UNITED STATES PATENT AND TRADEMARK OFFICE

APPLICATION NO.	FILING DATE	FIRST NAMED INVENTOR	ATTORNEY DOCKET NO.	CONFIRMATION NO.
09/886,741	06/21/2001	Vincent Chan	ATI.0100680	6028

Office Action Summary

DETAILED ACTION

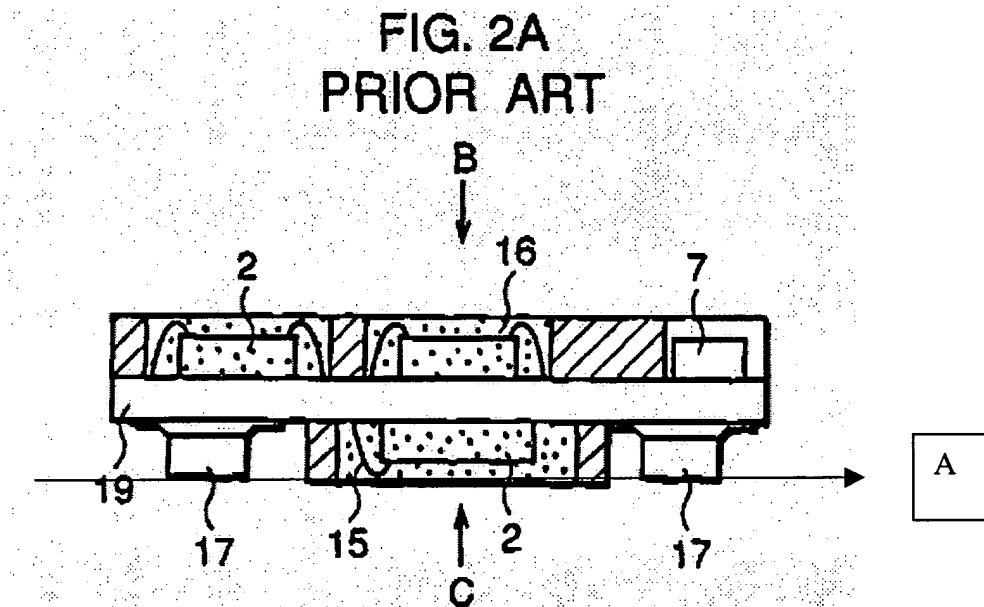
Furthermore, applicant argues "applicants submit that nowhere in the Office Action does the Examiner specifically point out where the references recites the claim limitation 'wherein the planar top surface of the encapsulated structure and the top surface of the packaged semiconductor die are of equal distance from the substrate.' ... Applicant submit that Tanioka

does not disclose Applicants' claimed subject matter." This argument is not persuasive. Tanioka clearly shows in Fig. 2A the planar top surface of the encapsulated structure (2) and the top surface of the packaged semiconductor die (17) are of equal distance from the substrate (look at the line A).

Next, applicant argues "Tanioka does not disclose, teach or suggest, claim 57's language including, inter alia, '... a ... graphics-processing die encapsulated on the package module in a structure having a planar top surface; and a packaged memory die having a top surface and attached to the package module; wherein the planar top surface of the encapsulated structure and the top surface of the packaged memory die are of equal distance from the substrate.,' nor does Tanioka disclose, teach or suggest the subject matter of claim 57 as a whole." This argument is not persuasive. Tanioka clearly shows in Fig. 2A the planar top surface of the encapsulated structure (2) and the top surface of the packaged semiconductor die (17) are of equal distance from the substrate (look at the line A in the previous page).

Next, applicant argues “Tanioka does not disclose, teach or suggest, claim 58’s language including, inter alia, ‘... a an unpackaged semiconductor die ... encapsulated in a structure having a planar top surface; and a packaged semiconductor die having a top surface and mounted on the first surface of the substrate; wherein the planar top surface of the encapsulated structure and the top surface of the packaged memory die are of equal distance from the substrate.,’ nor does Tanioka disclose, teach or suggest the subject matter of claim 58 as a whole.” This argument is not persuasive. Tanioka clearly shows in Fig. 2A the planar top surface of the a an unpackaged semiconductor die (2) ... encapsulated in a structure having a planar top surface; and a packaged semiconductor die (17) having a top surface and mounted on the first surface of the substrate (19); wherein the planar top surface of the encapsulated structure and the top surface of the packaged memory die are of equal distance from the substrate (look at the line A in the previous page).

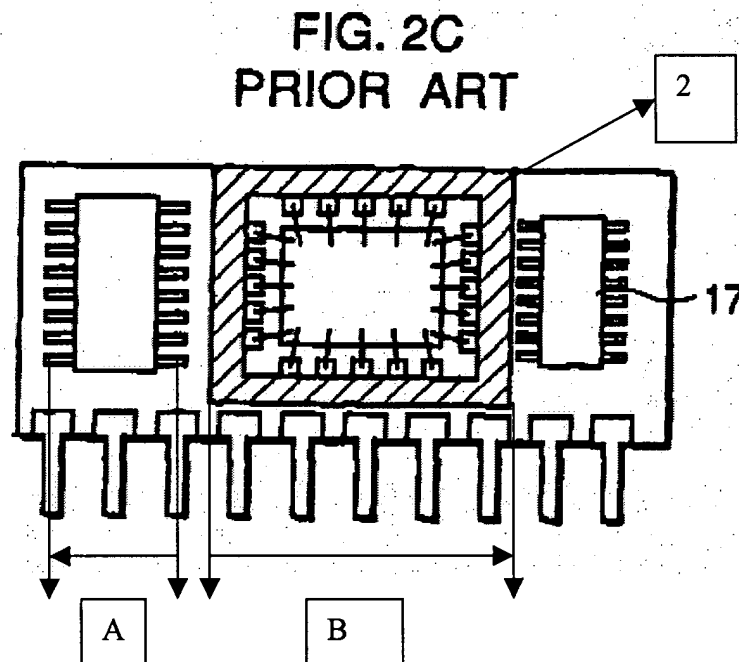
Next, applicant argues “Tanioka does not disclose, teach or suggest, either explicitly or implicitly, Applicants claimed, inter alia, wherein the encapsulated structure has a footprint greater than the footprint of the unpackaged semiconductor die.” This argument is not persuasive. Tanioka clearly discloses in Fig. 2A and Fig. 2C the encapsulated structure (2) having a footprint (B, see next page) greater than the footprint (A) of the unpackaged semiconductor die (17).
